## DEVELOPMENT APPLICATION ASSESSMENT REPORT

<b>Application Number:</b>	DA2024/0620
----------------------------	-------------

<b>Responsible Officer:</b>	Michael French
<b>Land to be developed (Address):</b>	Lot 64 DP 12072, 29 Waratah Street FRESHWATER NSW 2096
<b>Proposed Development:</b>	Construction of a secondary dwelling
<b>Zoning:</b>	Warringah LEP2011 - Land zoned R2 Low Density Residential
<b>Development Permissible:</b>	Yes
<b>Existing Use Rights:</b>	No
<b>Consent Authority:</b>	Northern Beaches Council
<b>Land and Environment Court Action:</b>	No
<b>Applicant:</b>	The Trustee For Hjk Family Trust

**Figure 1: Envelope non-compliance (western elevation)**

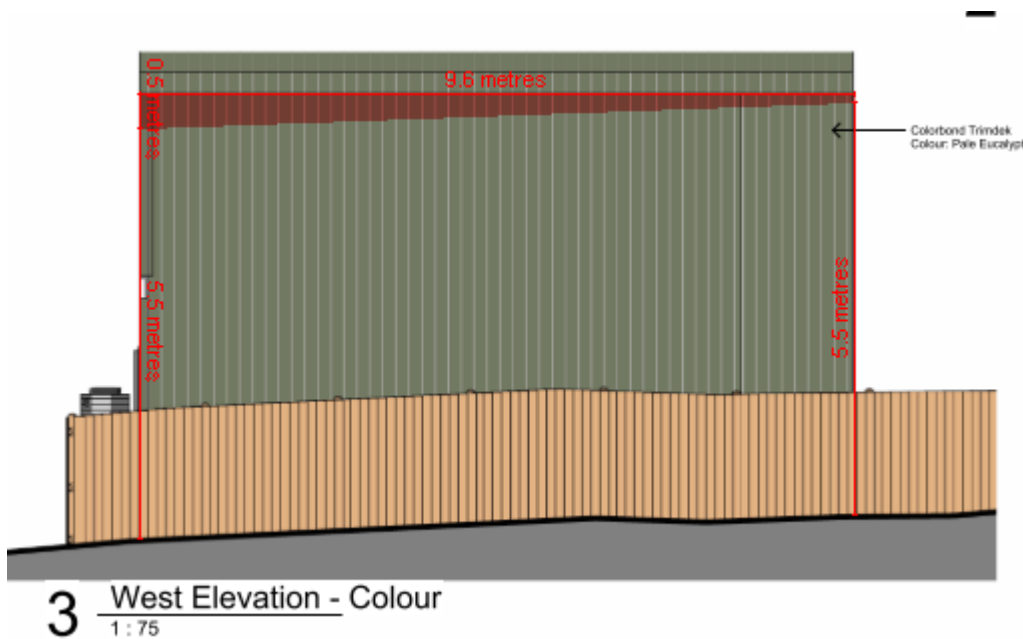
The proposed addition to the dwelling will form an encroachment on the western elevation for a length of 9.6m at a maximum height of 0.5m.

Along the western elevation, the envelope non-compliance is primarily attributed to the location of the existing garage below the proposed secondary dwelling. Whilst the breach extends 9.6m at a maximum height of 0.5m, it is considered that it will not adversely affect the amenity of adjoining or surrounding sites, nor does it unreasonably detract from the streetscape. In this instance, the variation to *Clause B3 Side Boundary Envelope* is considered to be supportable as the outcomes of the control have been met as outlined below.
